MIL-M-28787/82A
AMENDMENT 2
31 December 1992
SUPERSEDING
AMENDMENT 1
14 November 1983

MILITARY SPECIFICATION

MODULES, STANDARD ELECTRONIC

INVERTER, DIGITAL, KEY CODE RBG

FIGURE 6. V_{OUT} (low-loaded) test circuit for table IV.

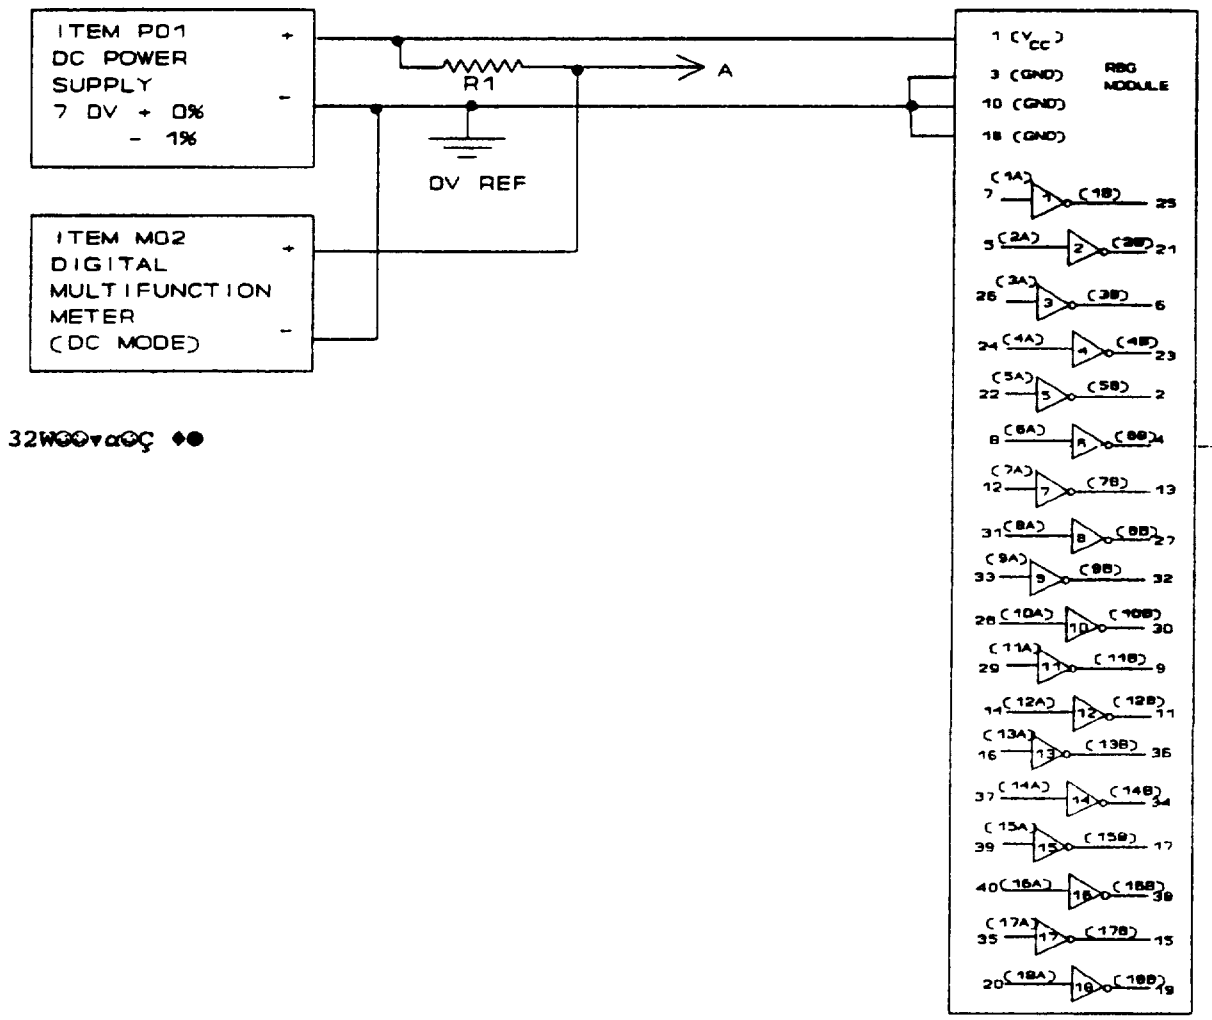
FIGURE 6: Delete and substitute new figure 6 as printed on page 4 of this amendment.

NOTE: R1 = 249Ω ± 1%, 1/4W.

FIGURE 10. Input clamp diode voltage test circuit for table VIII.

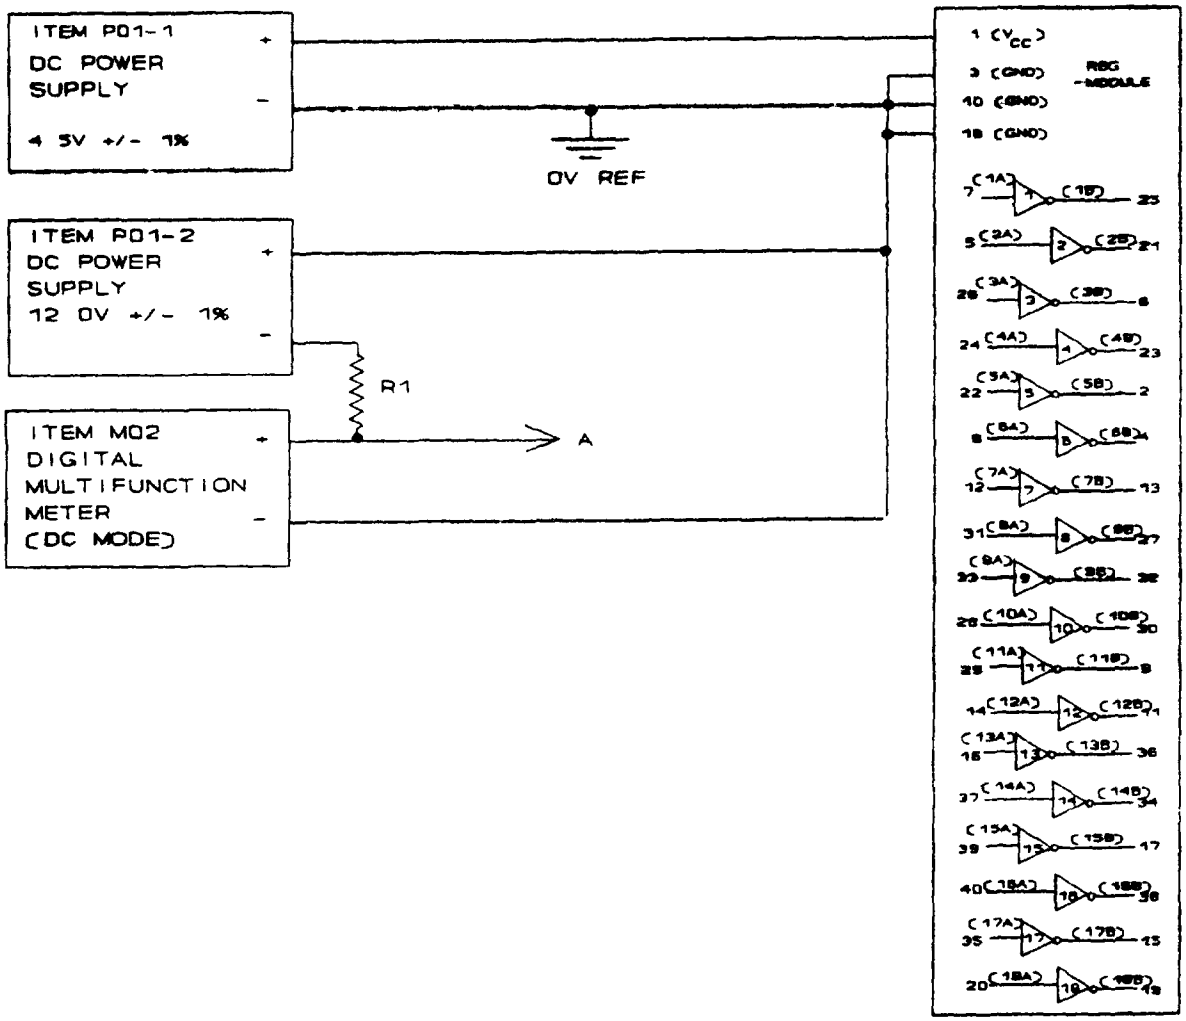
FIGURE 10: Delete and substitute new figure 10 as printed on page 5 of this amendment.

NOTE: R1 = 590Ω ± 1%, 1/4W.

FIGURE 11. Static output voltage (low-level and high-level) test circuit for tables IX and X.

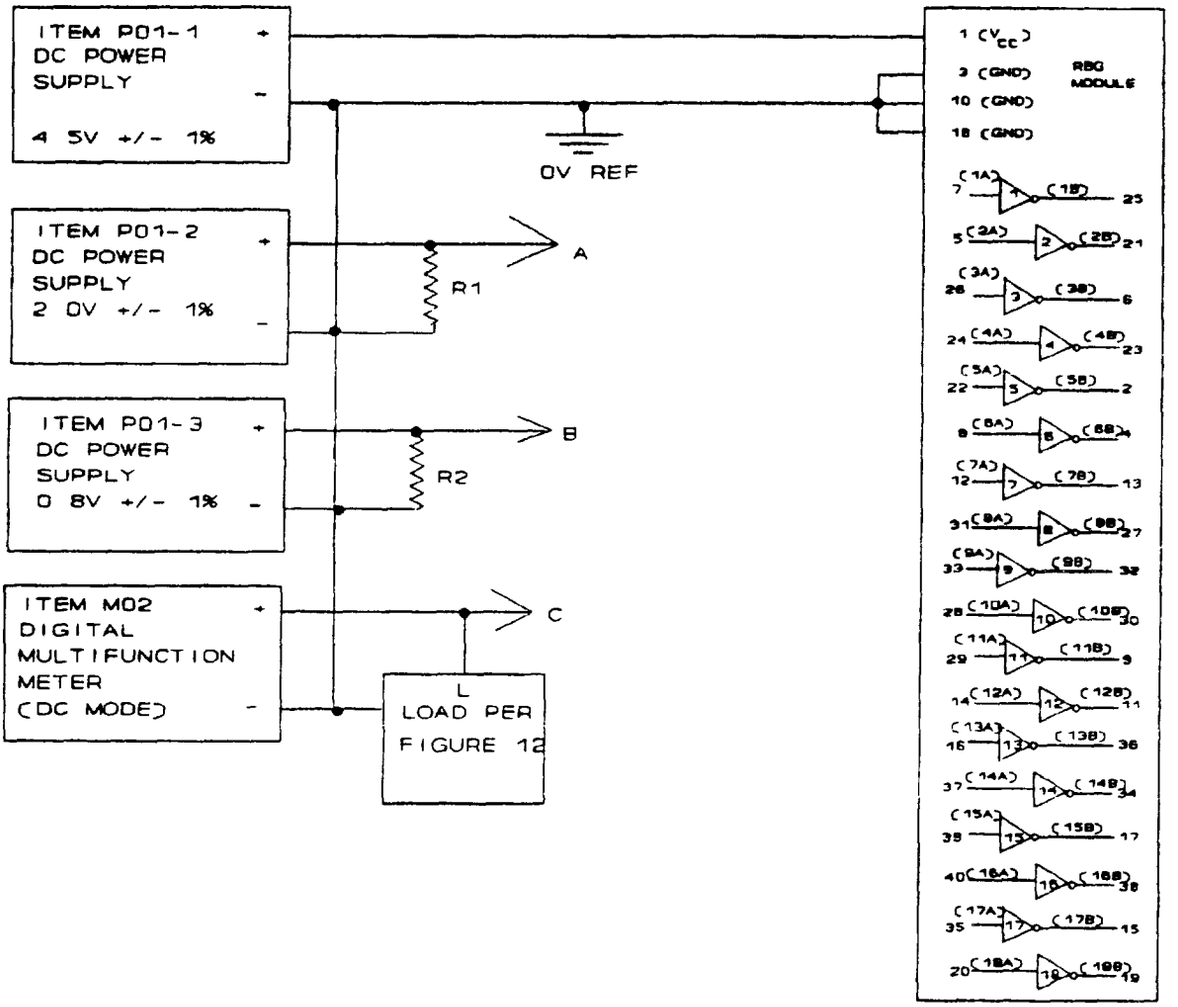
FIGURE 11: Delete and substitute new figure 11 as printed on page 6 of this amendment.

NOTE: R1 = R2 = 51Ω ± 5%, 1/2W.
